CO-OP MINING COMPANY

Please find attached, Co-Op Reply to Bear Canyon MRP Stipulations.

Co-Op Mining Company Reply to Stipulation of 10/30/85 MRP

Bear Canyon Mine ACT/015/025

Fig A-1

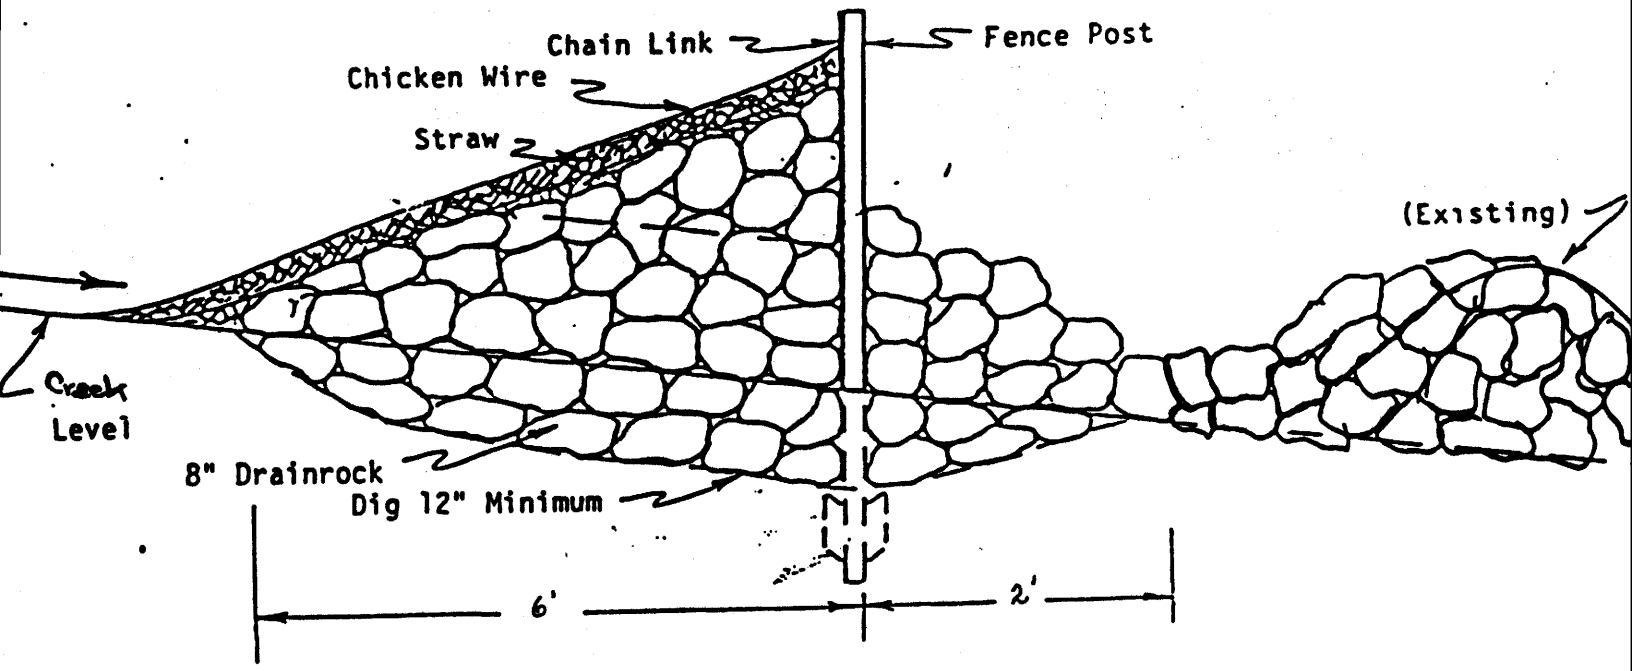
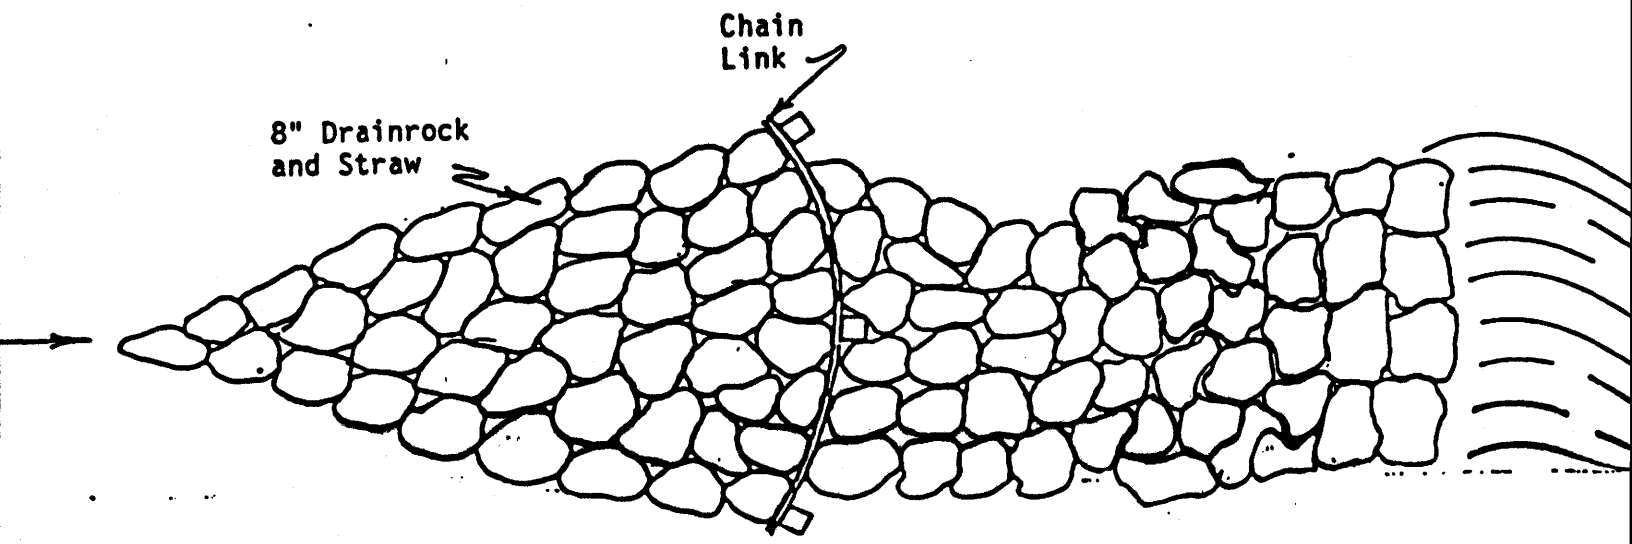
Stipulation 817.44-(1)-TM

1. The applicant shall provide, within 60 days of permit approval, revised plans and drawings for the proposed rock gabion structures for final reclamation of the Bear Canyon stream channel. The revised plans and drawings shall incorporate the compliance concerns noted in UMC 817.44 of this TA.

See Attachment "A" of this submittal "Revised Plans and Drawing" for proposed rock gabion structures.

The rock gabions, as pictured on Figure A-1 will be installed along Bear Creek as committed in the Scale house modification and placed at approximately 75' intervals adjacent to Sediment Pond "B" along Bear Creek. These three structures will be constructed as soon as weather permits (winter 1985-spring 86.)

Due to the excessive silt load associated with Bear Creek's natural drainage area, it is anticipated that in a relatively short time the filtration aspect of the gabions will be negated through natural silt loading. However, the function of the gabion should not be negated but simply modified to represent a check dam with a positive enhancement value associated with the expansion of increased reparian habitat.

Figure B-1

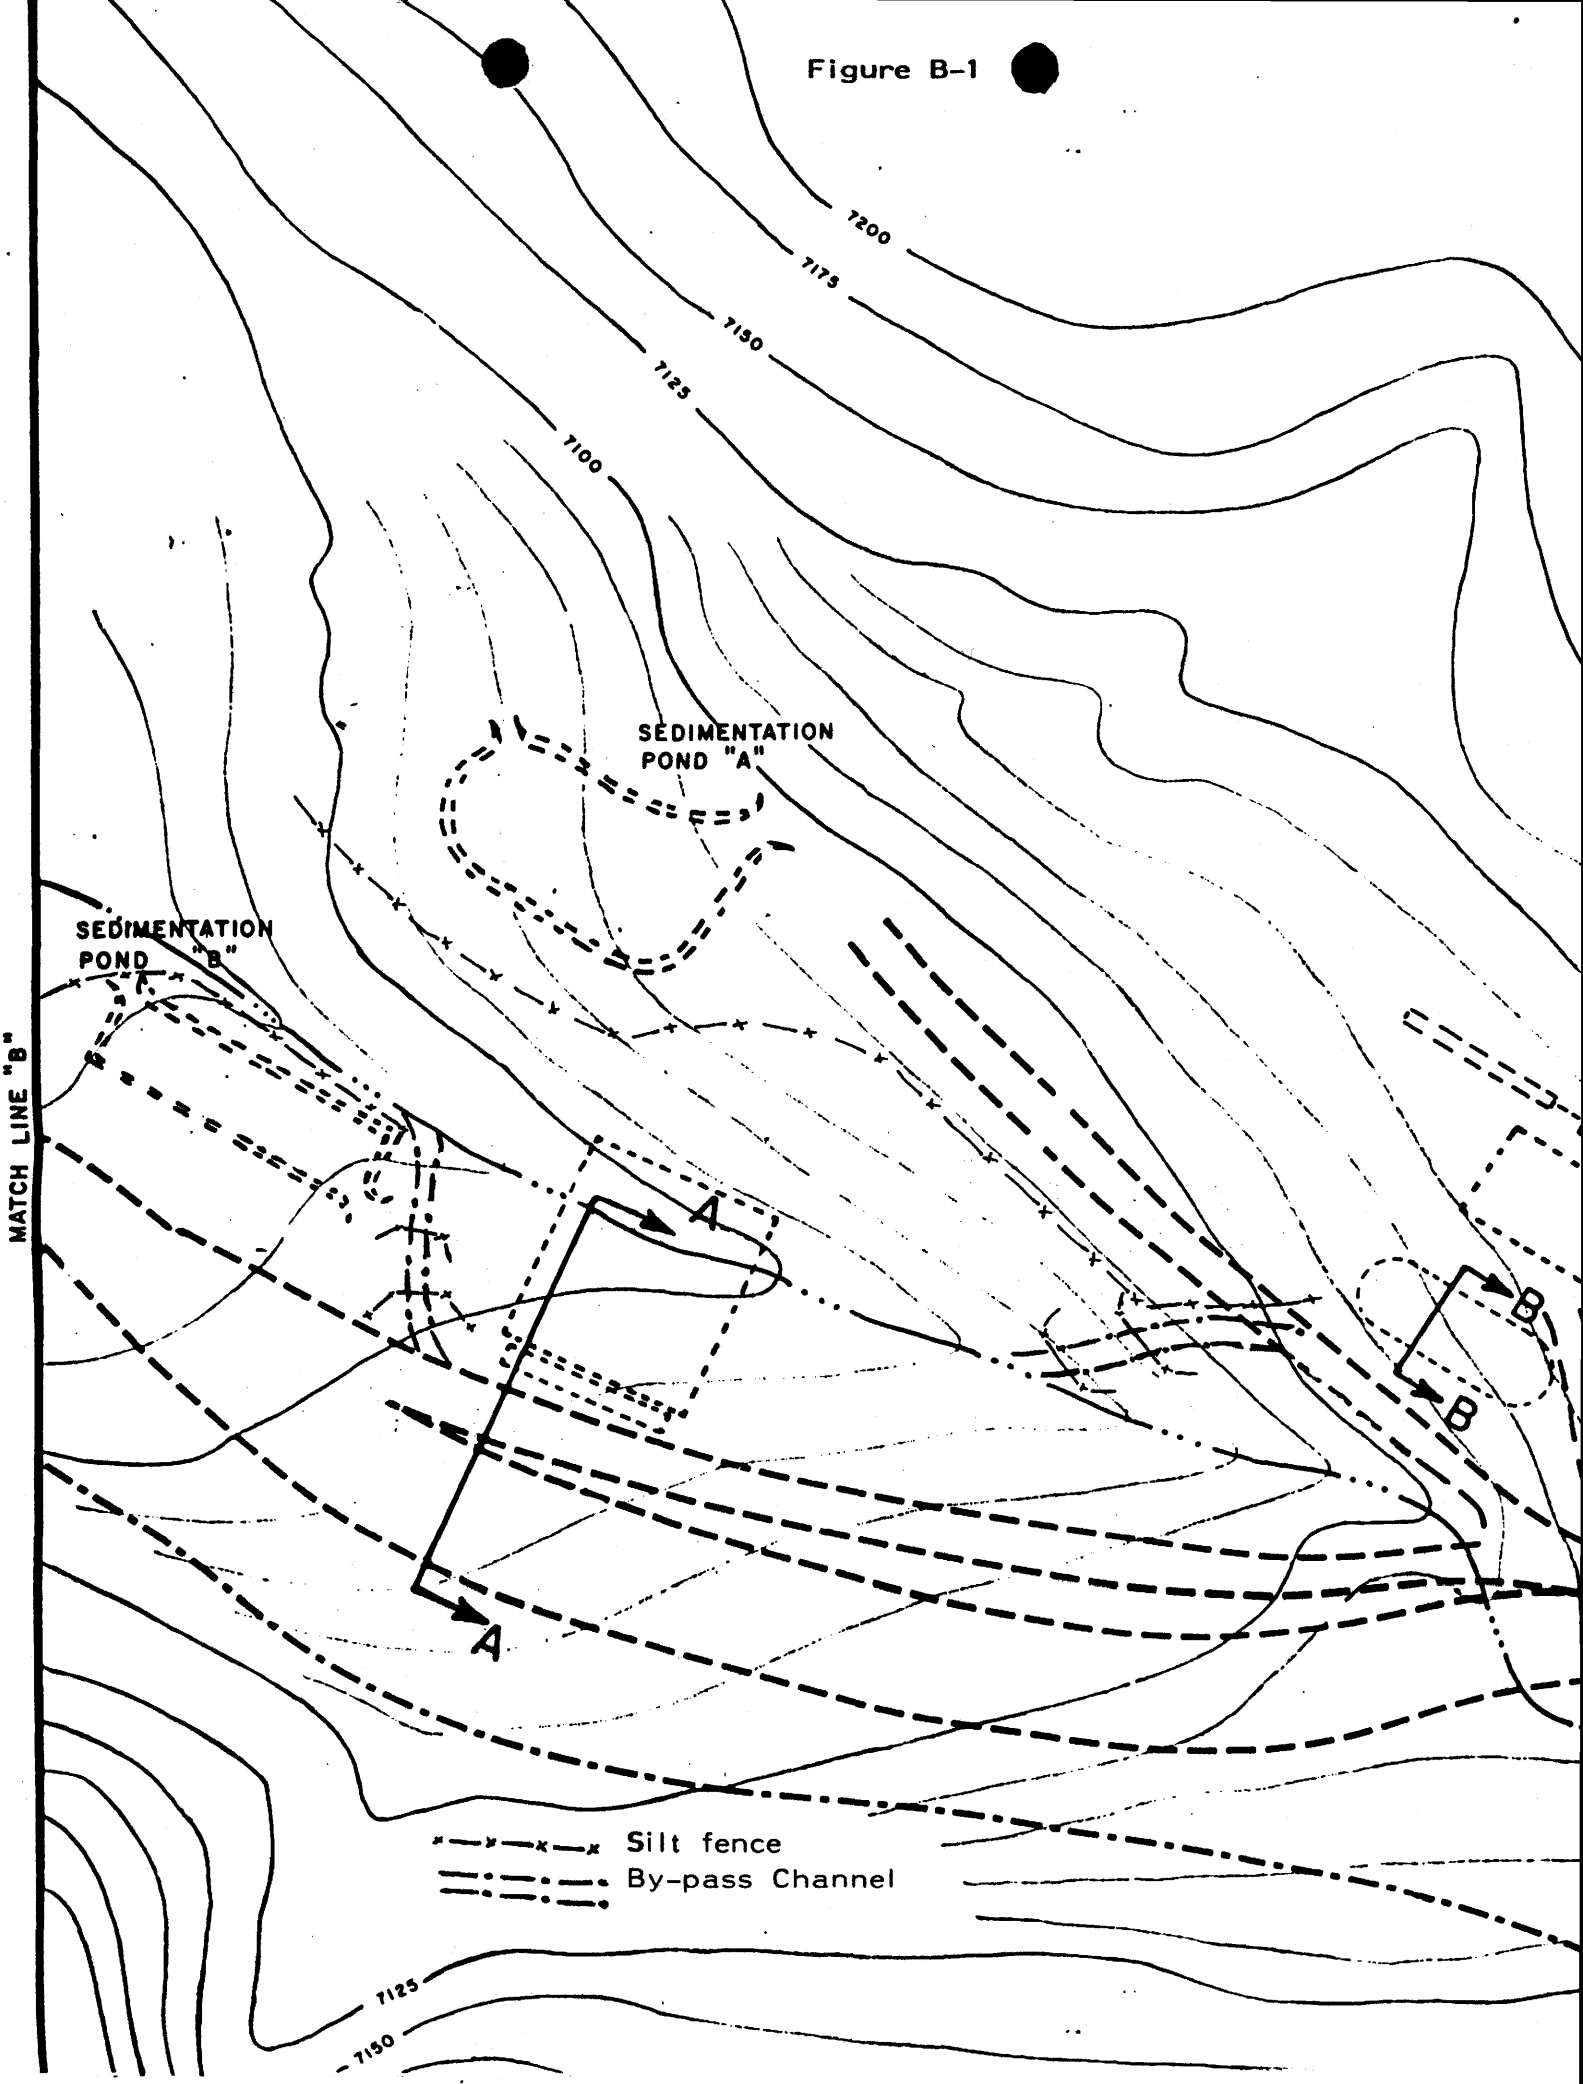
Stipulation 817.46-(1)-TM

1. The applicant must provide, within 60 days of permit approval, detailed plans for removal of the sedimentation ponds during final reclamation. The applicant must provide plans to divert flows going to and around the sedimentation ponds during final reclamation of the ponds.

Sediment ponds "A" and "B" will be the last structures to be removed. Both ponds will be maintained until revegetation is established on all upslope reclaimed lands. When revegetation has been established, the ponds will be decanted, allowed to dry, by implementing newly created by-pass channels. The embenkments will be removed by placing this material within the ponds in a maximum of two foot lifts and compacting the material to 90% of surrounding undisturbed soils. Top soil will then be placed over the newly filled pond to an approximate thickness of 6". This material will be ripped to a depth of 12" to insure a non-compacted seed bed is available for revegetation. The method of revegetation is addressed in Chapter 9 Section 9-5 . Seed mix is included on pages 9-22 - 9-24. Silt fences will be installed along the creek side of the disturbance on each pond and maintained until vegetation is re-established, at which time the silt fences will be removed. Figure "B-1" attached, details locations of the by-pass channels as well as the installation of silt fences.

That portion of the by-pass channel which constitutes new disturbance and prior to intersection of the original channels will be lined with rip-rap having a median diameter (D-50) of 6" and a maximum diameter of 12". This size should be stable for channel bottom for velocities as high as 9 feet/second according to the Bureau of Reclamation approach.

Decant culverts will be salvaged if possible. Otherwise, they will be disposed of in an approved landfill.

NON-COAL STORAGE AREA	BEAR CANYON	FIGURE NO 1-1

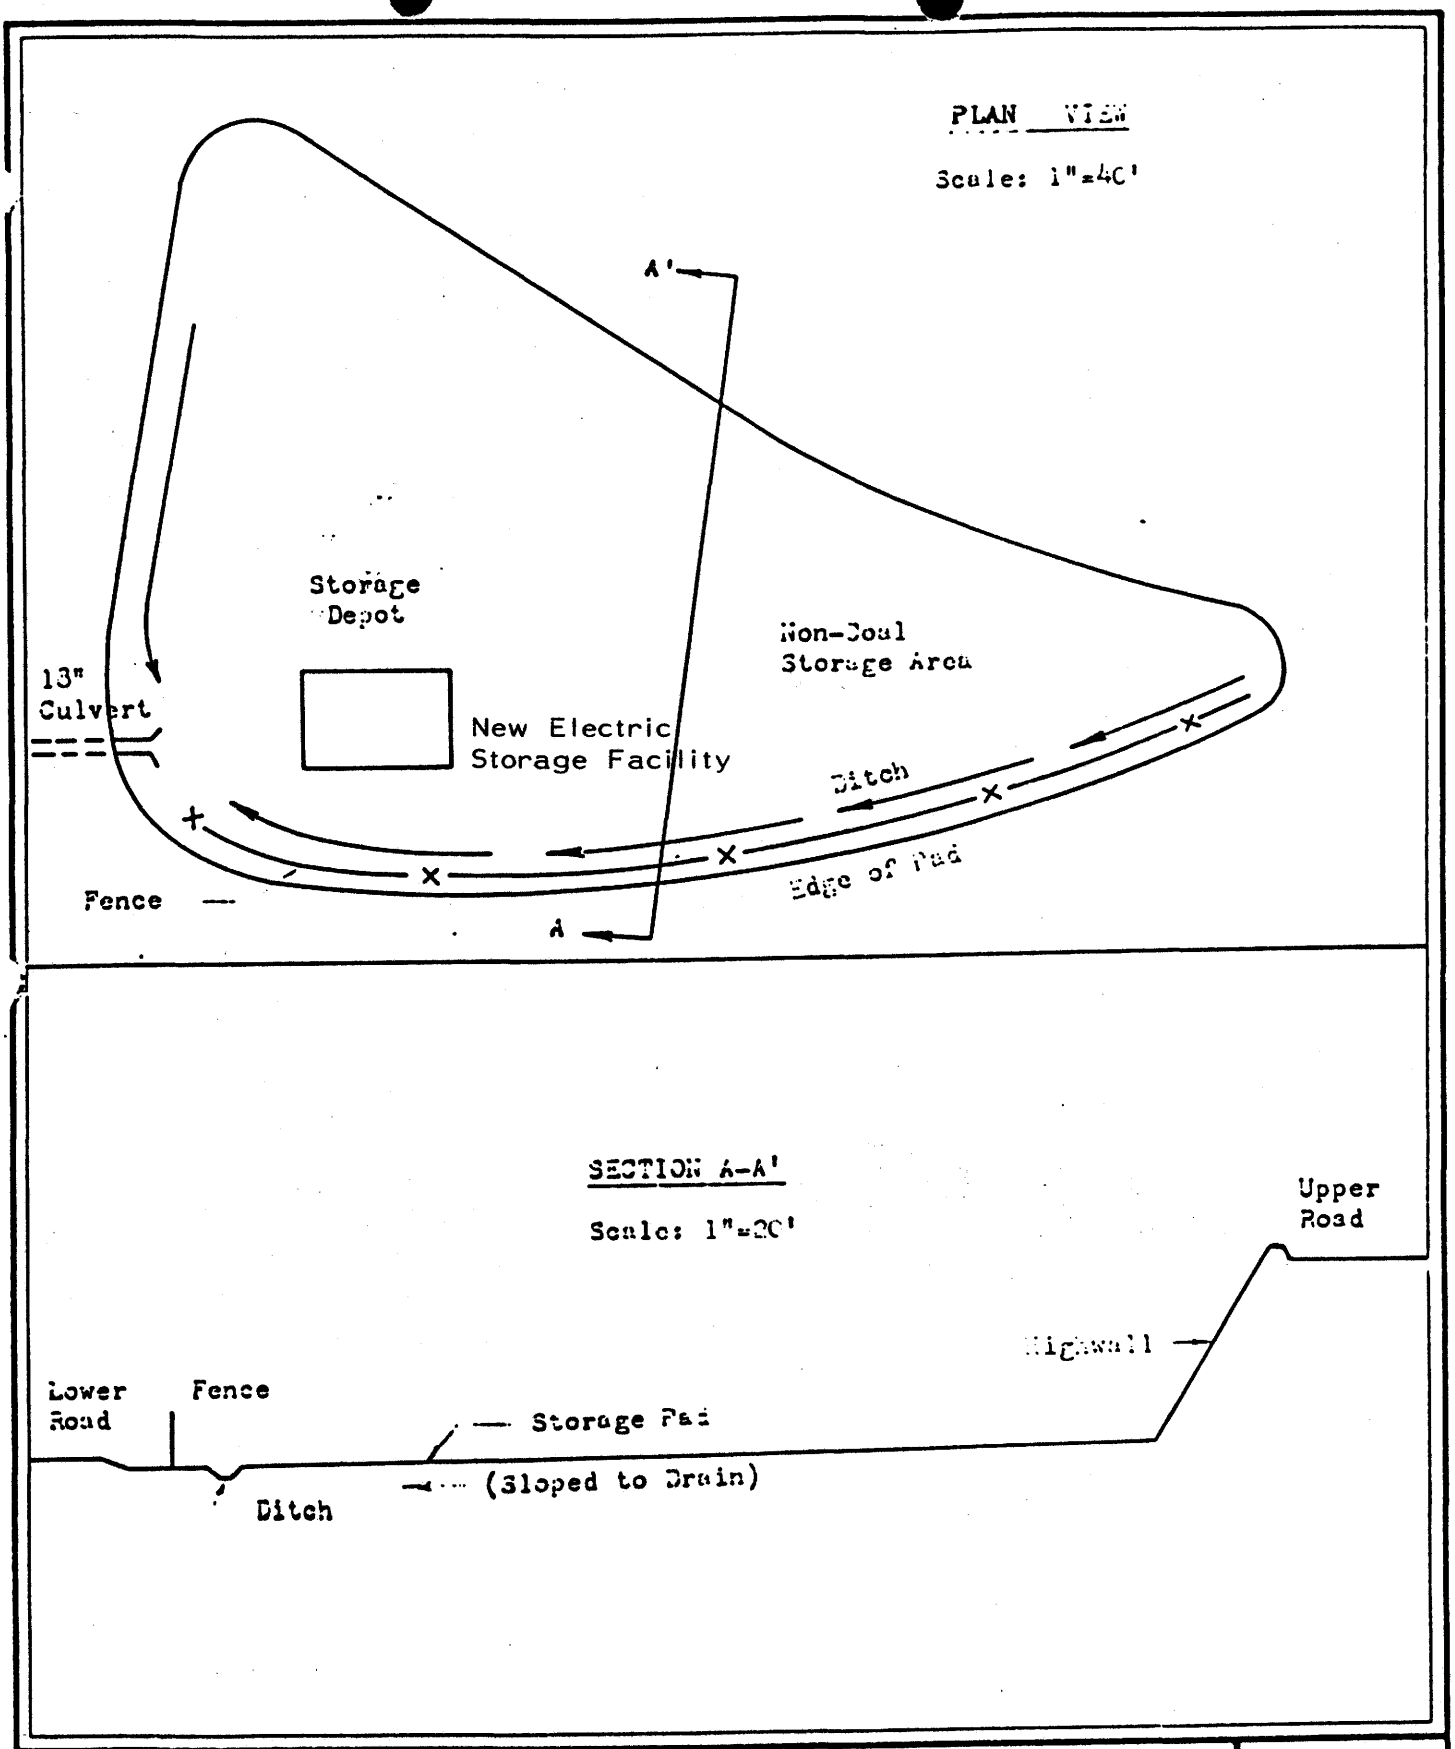
Stipulation 817.57-(1)-TM

1. The applicant must submit, within 60 days of permit approval, a map showing a new location for the electrical storage area on the disturbed area. Within 30 days of Division approval, Co-Op must relocate the electrical storage area to the approved location.

The existing electrical storage facility (old box car) was in place prior to the Bear Canyon Mine starting. It has been utilized as a temporary storage facility pending completion of the non-coal storage yard and depot as shown on attached Figure 1-1, and as listed in Chapter 3 Appendix 3.3.4.-A. This yard and structure will be completed by August, 1986, at which time all materials presently stored adjacent to the yard will be relocated with the exception of the old box car which will be demolished and hauled to an approved sanitary land fill.
